Errata

AM64x/AM243x Processor Silicon Revision 1.0, 2.0

Figure 2-1. Interrupt Aggregator Version 1.0

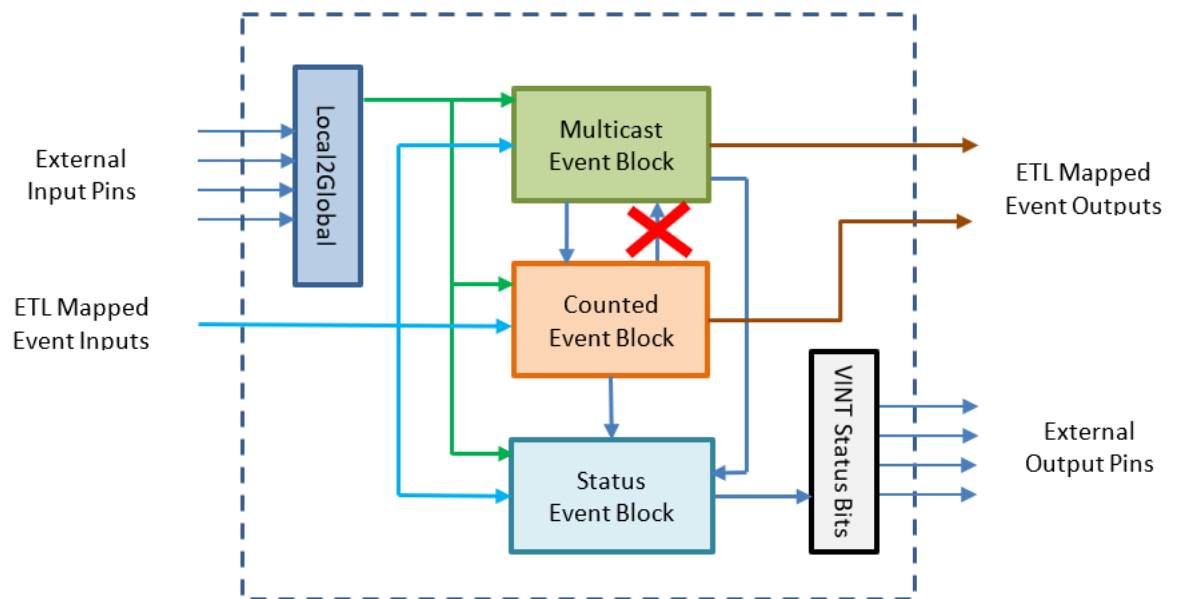
An issue was found after design that could cause the IA to deadlock. The issue occurs when event “loops” occur between these three processing blocks. It is possible to create a situation where a processing block can not output an event because the path is blocked, and since it can not output an event, it can not take any new input events. This inability to take input events prevents the output path from being able to unwind, and thus both paths remain blocked.

Workaround(s): Figure 2-1 shows the conceptual block diagram of IA 1.0. Potential loops are avoided by adopting the policy of not allowing the counted event block to send events to the multicast block. This method was chosen because it is more common to split an event first, and then count one while sending the other elsewhere. With this path blocked by convention, it is not possible for a single event to visit any block more than once and thus not possible for paths to become blocked so long as the outputs remain unblocked.

Figure 2-2. Interrupt Aggregator Version 1.1

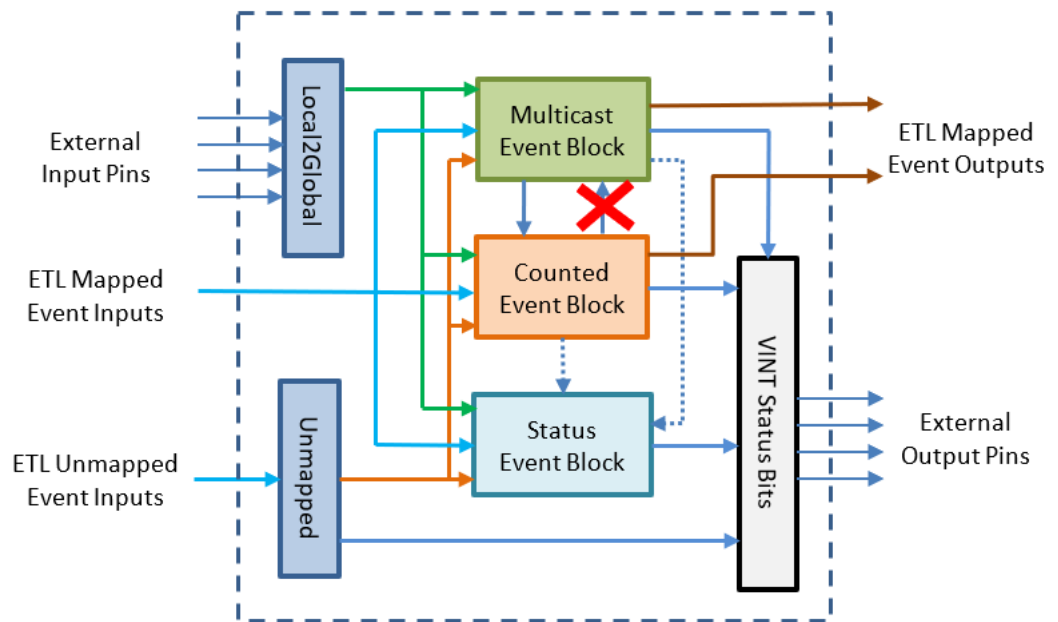
Figure 2-2 shows the diagram of IA 1.1. Note that the same policy applies to avoid deadlock. In addition, the paths shown as dotted lines (sending ETL events from the multicast or counted blocks to the status event block) is now discouraged. These paths still function as before for backward compatibility, but are rendered obsolete as all blocks are now able to directly set status event bits.

By following the conventions outlined here, the system is safe from looping hazards that can create a deadlock scenario.

Figure 2-3. MDIO Emulation via Manual Mode using PRU Core

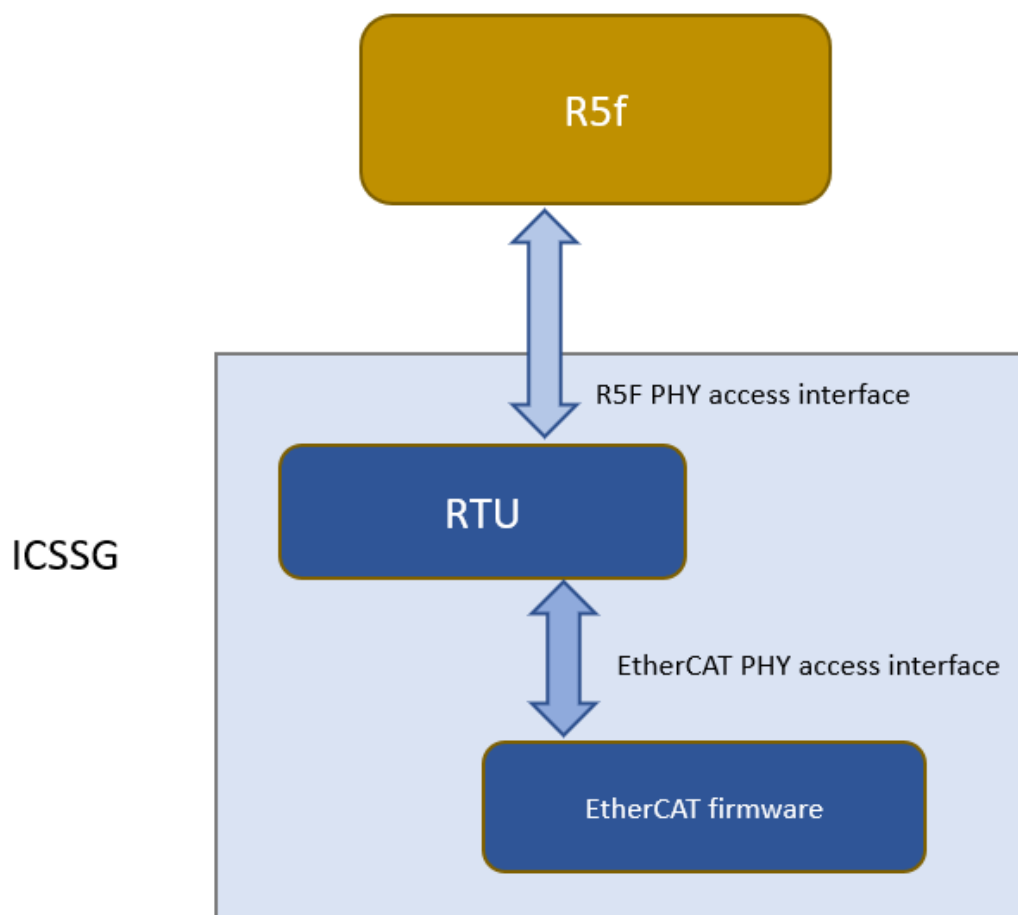
Details: It is possible that the MDIO interface of all instances of CPSW and PRU-ICSS peripherals (if present) returns corrupt read data on MDIO reads (e.g. returning stale or previous data), or sends incorrect data on MDIO writes. It is also possible that the MDIO interface becomes unavailable until the next peripheral reset (either by LPSC reset or global device reset with reset isolation disabled in case of CPSW).

In case of PRU-ICSS, the loading of the software workaround may be reduced by using the MLINK feature of MDIO to do automatic polling of link status via the MIIx_RXLINK input pin to PRU-ICSS which must be connected to a status output from the external PHY which does not toggle while the link is active. Depending on the specified behavior of the external PHY device, this PHY status output may be LED_LINK or LED_SPEED or the logic OR of LED_LINK and LED_SPEED. Refer to the MDIO section of TRM for details on using the MLINK feature of MDIO. This feature is not available on the CPSW peripheral.

For EtherCAT implementation on PRU-ICSS, the software workaround will be done in RTUx/ TX_PRUx Core. The core will have to be dedicated for workaround, which means this can't be used for other purpose. The implementation will support two user access channels for MDIO access. This provides option for R5f core and PRU core to have independent access channel. The APIs will be similar to the ones we will have in RTOS Workaround implementation.

EtherCAT will continue to use PHY fast link detection via MDIO MLINK bypassing state m/c for link status (as this path is not affected by errata). This makes sure that cable redundancy related latency requirements are still met.
